COUNCIL ASSESSMENT REPORT

SYDNEY CENTRAL CITY PLANNING PANEL

PANEL REFERENCE & DA NUMBER	PPSSCC-493 - DA 426/2024/JP
PROPOSAL	Mixed Use Development Including a Hotel, Commercial Premises, Food and Drink Premises, Gymnasium and Childcare Centre
ADDRESS	14-16 Brookhollow Avenue Norwest
APPLICANT	ICH Corp Pty Ltd
OWNERS	BHA Corp Pty Ltd
DA LODGEMENT DATE	26 September 2023
APPLICATION TYPE	Development Application
REGIONALLY SIGNIFICANT CRITERIA	Clause 2.19, Schedule 6 of the SEPP (Planning Systems) 2021
ESTIMATED DEVELOPMENT COST	\$36,710,631.73 (excluding GST)
CLAUSE 4.6 REQUESTS	The Hills LEP 2019 Clause 4.3 Height of Buildings SP4 Enterprise
KEY SEPP/LEP	SEPP (Transport and Infrastructure) 2021 and The Hills LEP 2019
TOTAL & UNIQUE SUBMISSIONS KEY ISSUES IN SUBMISSIONS	Nil
DOCUMENTS SUBMITTED FOR CONSIDERATION	Statement of Environmental Effects – Urbis Architectural Plans – Group GSA Architectural Design Report – Group GSA Landscape Plan – Vision Dynamics Traffic Impact Assessment – Stantec Acoustic Impact Assessment – Rodney Stevens Acoustics Heritage Impact Statement – Urbis Arboricultural Impact Assessment Report – Advanced Treescape Consulting

CPTED Assessment – Group GSA Sto

Figure: Image indicating extent of height exceedance

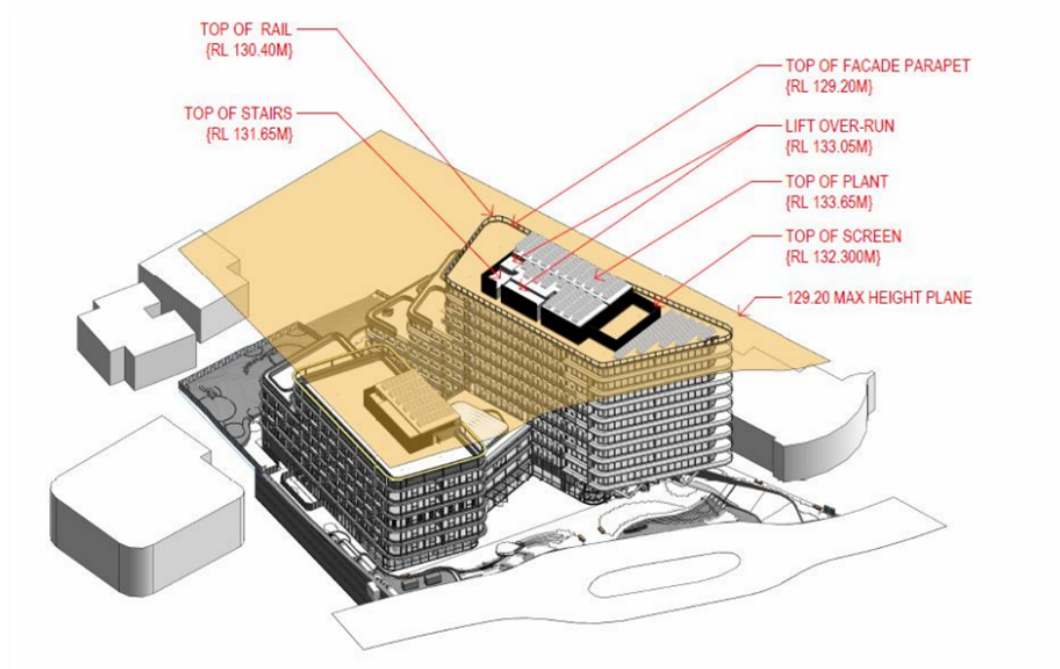
The extent of the height variation is summarised in the table and figure below :

Building Component in Western Tower	Maximum Building Height Development Standard	Maximum Height	Proposed Height Exceedance and Extent of Variation
Top of roof access stairs	RL 129.2m	RL 131.65m	2.45 metres (6.4%)
Top of rail	RL 129.2m	RL 130.40m	1.2 metres (3.1%)
Lift overrun	RL 129.2m	RL 133.05m	3.85 metres (10.1%)
Top of plant	RL 129.2m	RL 133.65m	4.45 metres (11.6%)
Top of screen	RL 129.2m	RL 133.80m	4.6 metres (12%)

The proposal will be compatible with that of adjoining development and the streetscape as the height variation only relates to a lift overrun and plant equipment within the western tower. These elements will not be visible from the streetscape. The eastern tower has a maximum height of RL 119m which is 10m less than the maximum height limit.

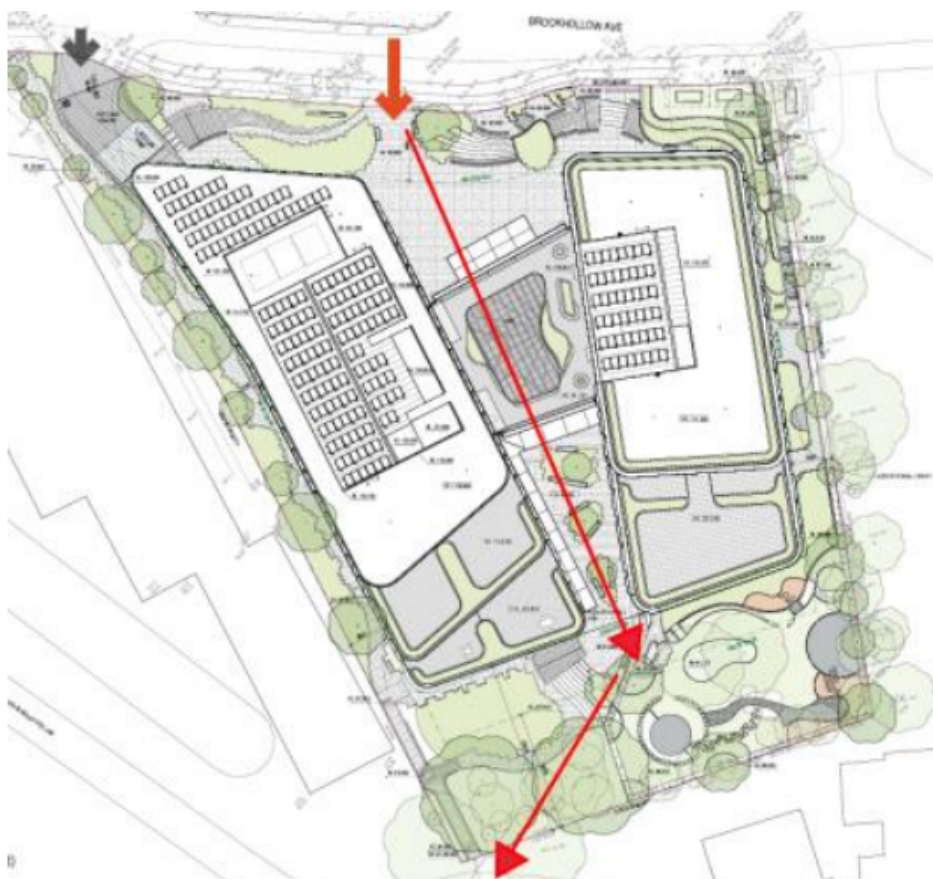
DCP Part D Section 25 requires the development must provide a pedestrian site through linkage between Brookhollow Avenue with Fairmont Avenue Reserve that is to be generally consistent with Figure 6. The Applicant is of the view that the proposal complies with this control. However, the proposed pedestrian site linkage is through an enclosed space and adjoins another pedestrian link along the western side of the site which is a variation to the below figure.

The Applicant provides the following:

The proposed through site link through the central atrium offers a safe, legible, and comfortable environment which encourage pedestrian flow...the atrium offers a great solution for an active atrium 24/7 which further improves the legibility of the through site link.

The proposal will provide a pedestrian link that is accessible by the public 24 hours, 7 days a week and will maintain a closed-circuit television system on the premises to ensure safety for pedestrians. The pedestrian link provides an accessible path of travel with a chair left at the rear of the premises. In this regard, the proposal will meet the objectives of the control and the variation can be supported.

Bulk, Scale and Massing

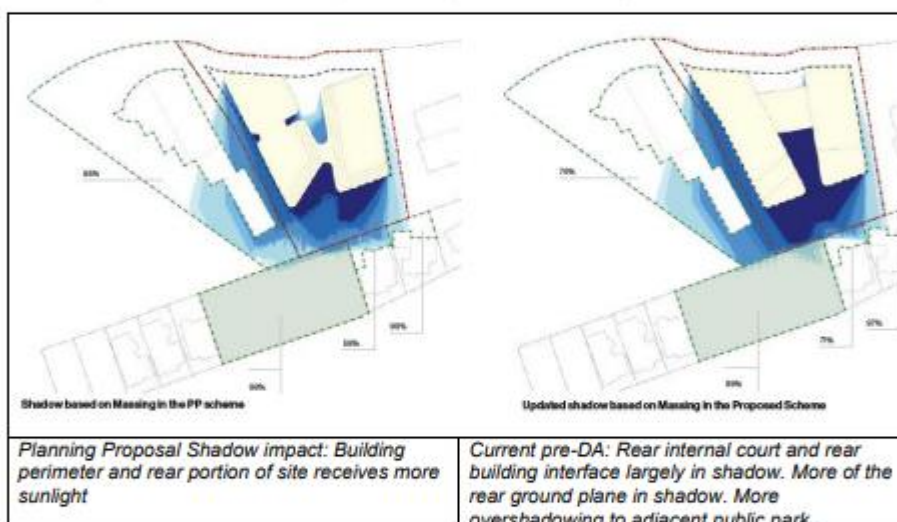
7. *The bulk and massing of the development is accentuated by the scale of the proposed central atrium portion of the building. The resultant built form presents as a single building spanning the width of the site, rather than two discrete buildings that are linked by a low podium building (as envisaged by the site DCP). The DCP images indicate elegant tower-like structures over a single connective level connective podium, which would result in more acceptable bulk and massing that is more likely to exhibit design excellence.*

New Comment: This comment remains relevant. The Panel advises that the removal of stepped floorplates and facades from the central atrium portion of the buildings will better present the development as being two discrete buildings rather than one single large mass. Although not meeting compliance with the DCP controls, this improves the impact of the bulk scale and massing of the built form.

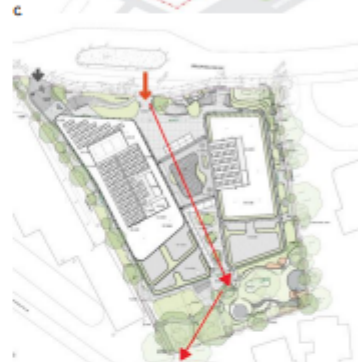
Site planning and built form strategy		
3	The Panel is concerned that no clearly accessible public pedestrian cross site link has been provided. The future character statement identified in the DCP (refer part 4.4) indicates that this is an integral part of the desired site planning strategy and has yet to be addressed to the Panel's satisfaction.	This comment remains relevant. The Panel reiterates that the wayfinding is not immediately legible and that the central building link needs to present as being available as 24/7 public access. The Panel suggests that the Applicant give further consideration to the 2 options for through site links, as both are demonstrating mixed success with respect to safety and accessibility. It may be worth further exploring how through site links on the site can meet the objectives of the DCP	The proposed through-site link is positioned centrally, offering direct on-grade access to Brookhollow Avenue and seamlessly traverses through the active atrium space towards the rear of the property, with a potential connection to Fairmont Avenue. This design ensures accessibility, providing visual connectivity to various activities throughout the site. It creates a safe, easily navigable, and comfortable environment, encouraging pedestrian traffic with continuous surveillance 24/7. Additionally, an alternative emergency access along the western boundary is included. Please refer to the image below for an overview of the overall concept and site plan.

requirement in providing the link and test the validity of both options. The Panel advised that the southern link presents some CEPTD issues. Both links should be fully accessible as cross site links.

4	There are a range of strategies that could achieve a successful public 24/7 pedestrian cross site link adjacent to tall buildings and also allow sunlight to enter into the public spaces at ground level. The proposal must demonstrate that what is proposed is a superior outcome to other options that may have been considered.	This comment remains relevant	The proposed through site link through the central atrium offers a safe, legible, and comfortable environment which encourage pedestrian flow. Refer drawing no. A6020 for the solar amenity of the through site link. Furthermore, as the Panel noted in the item no. the atrium offers a great solution for an active atrium 24/7 which further improves the legibility of the through site link. Refer item no. 18.
5	The Development Application should provide plans with measurements indicating the minimum building separation between building blocks A and B	This comment remains relevant. The Panel notes this information has been provided.	As noted by the Panel the requested information is provided and this item is closed out
